**RE: Draft Bankstown Master Plan**

**RE: SUBMISSION TO THE DRAFT BANKSTOWN TOWN CENTRE MASTERPLAN**

**Re: Bankstown City Centre - March 2021 – Master Plan – Draft for Exhibition**

# **Draft Bankstown City Centre and Campsie Town Centre Master Plans**

Figure 1: Framework Map (SINSW Annotations)

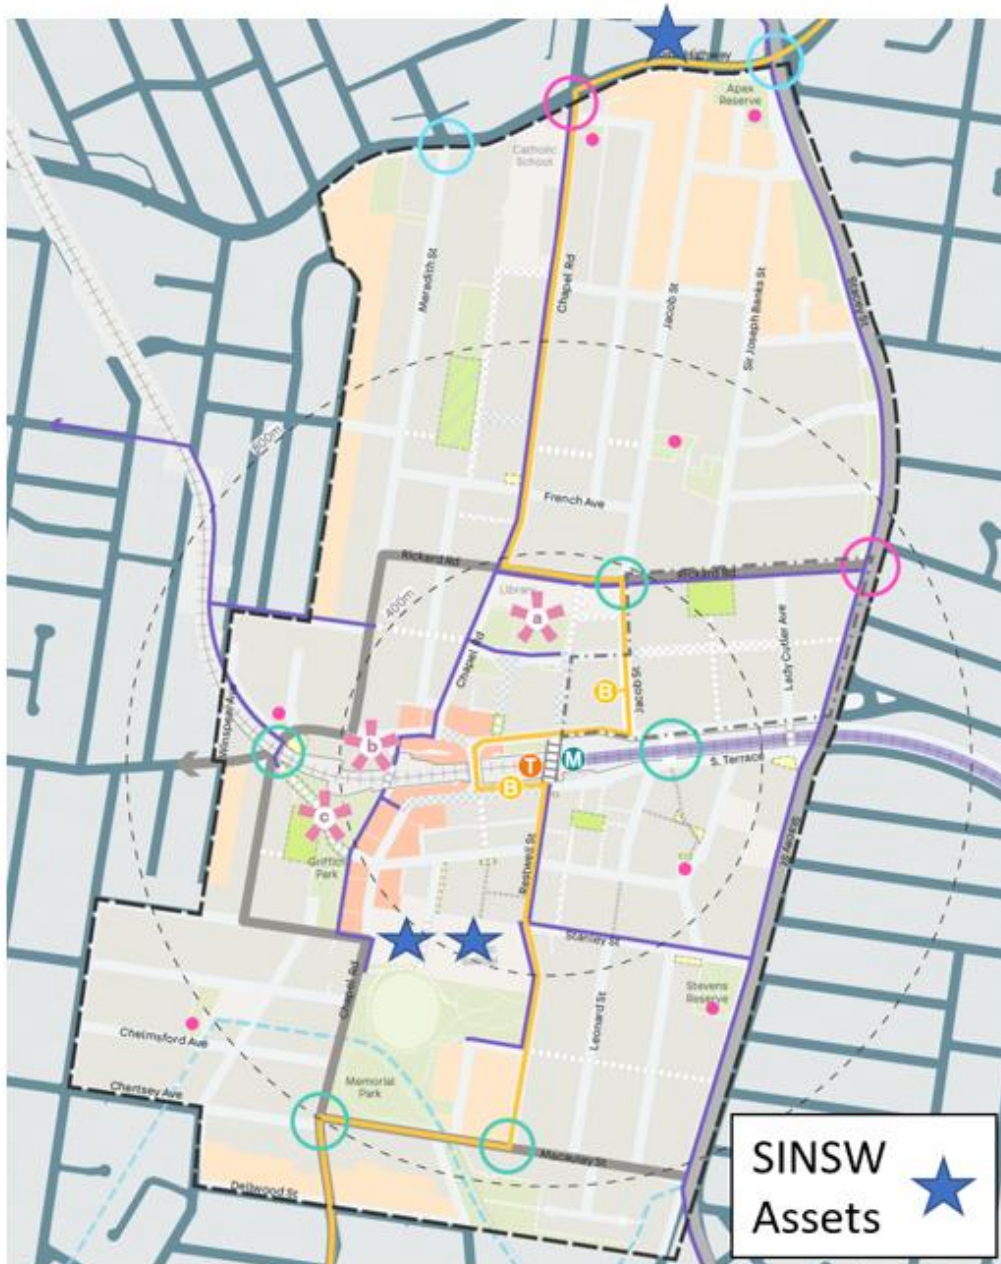
The following SINSW assets are located within the Bankstown City Centre (refer **Figure 1** below):

SINSW notes that the Draft Masterplan seeks building heights ranging from 16 storeys up to 22 storeys and floor space ratios (FSR) from 4.5:1 up to 6:1 directly adjoining Bankstown PS and Bankstown Girls HS to the north. This is an increase on the current height allowed pursuant to the *Bankstown Local Environmental Plan 2015* (the LEP).

As overshadowing plans do not accompany the Draft Masterplan documentation, SINSW are unable to determine if the density sought adjoining these schools would result in adverse solar access outcomes. SINSW recommends that the height and bulk of building envelopes sought by the Draft Masterplan minimise impacts of overshadowing on school grounds.

SINSW also notes that the map on page 90 of the Draft Masterplan seeks to establish a pedestrian and cycling link through the existing internal car park for the Bankstown Girls HS and Bankstown PS sites to Memorial Park to the south, and Mona Street to the north.

Figure 1. Dwellings within 400m of any public open space – Source Australian Urban Observatory

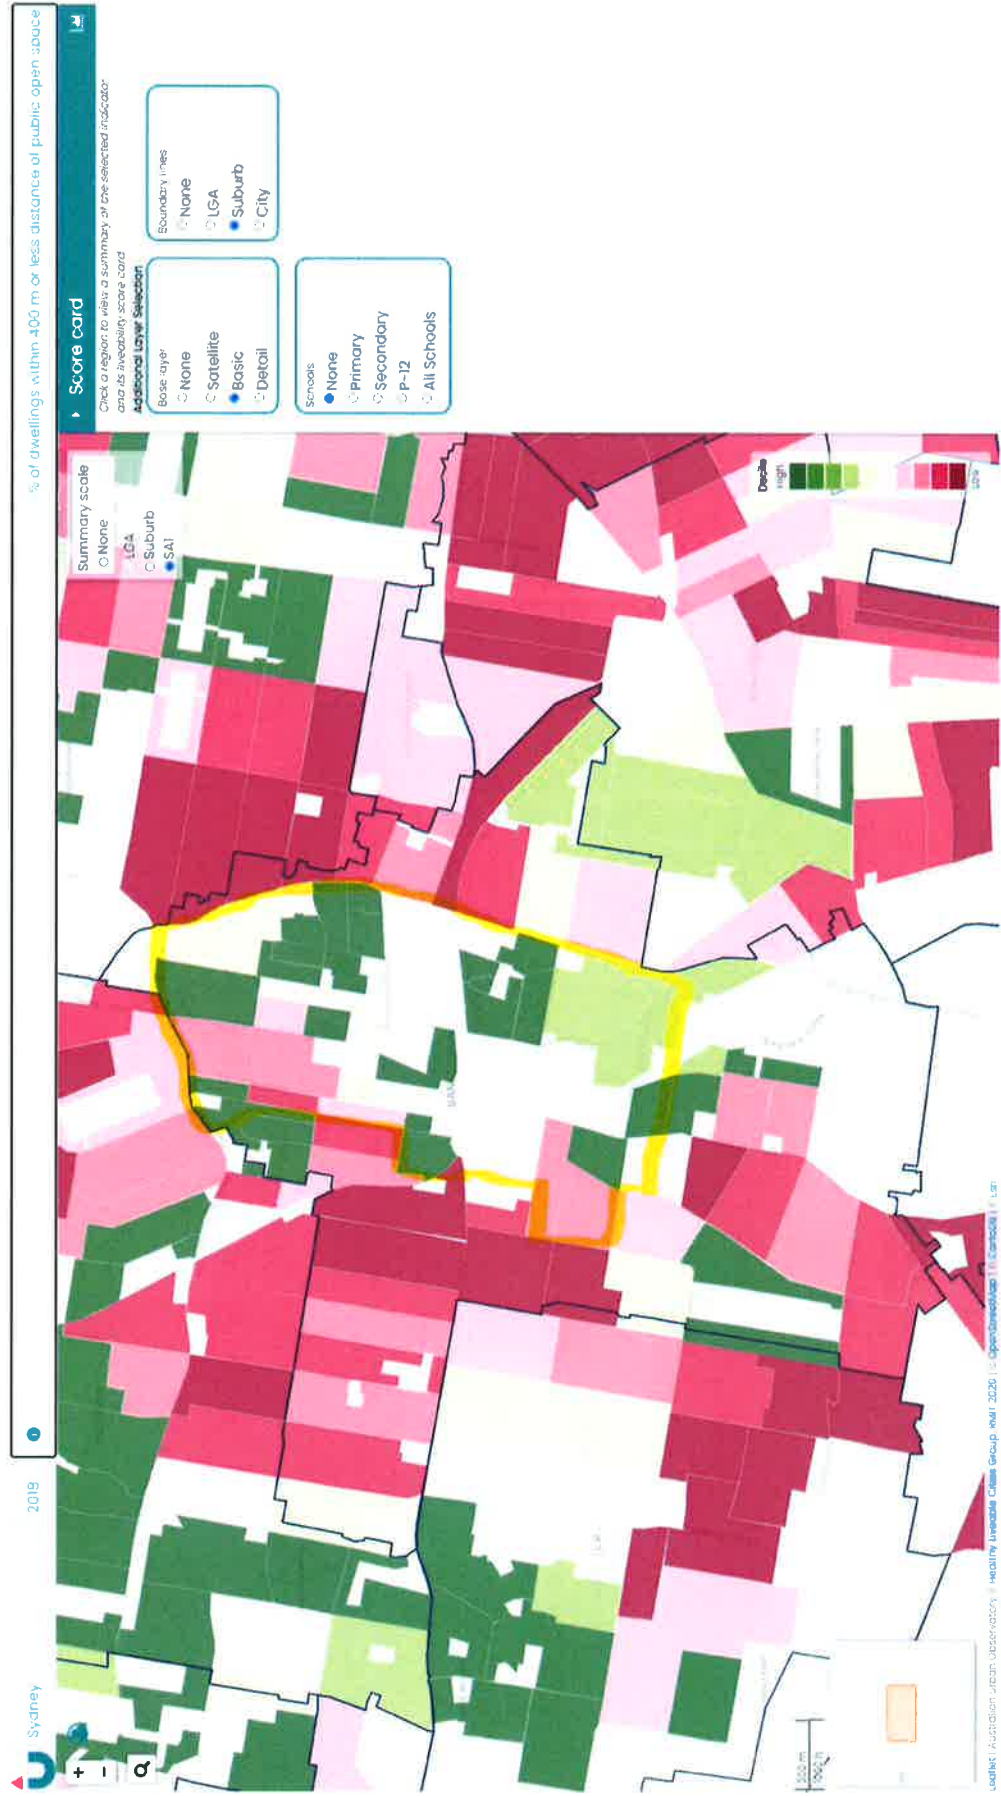
Pages 79-82. Objective 5.1	<p>We strongly support the objective and related actions aligning urban renewal with delivery of new and improved open space. The Australian Urban Observatory have collated data on a range of urban metrics that are known to impact on health outcomes. Whilst Bankstown does reasonably well at providing any small open space within 400m of homes (refer to Figure 1 below), it has large sections of the community that are not close to a larger public open space greater than 1.5hectares (Figure 2.).</p> <p>Open spaces larger than 1.5 hectares can appeal to larger sections of the community because they are able to incorporate multiple full-sized playing</p>
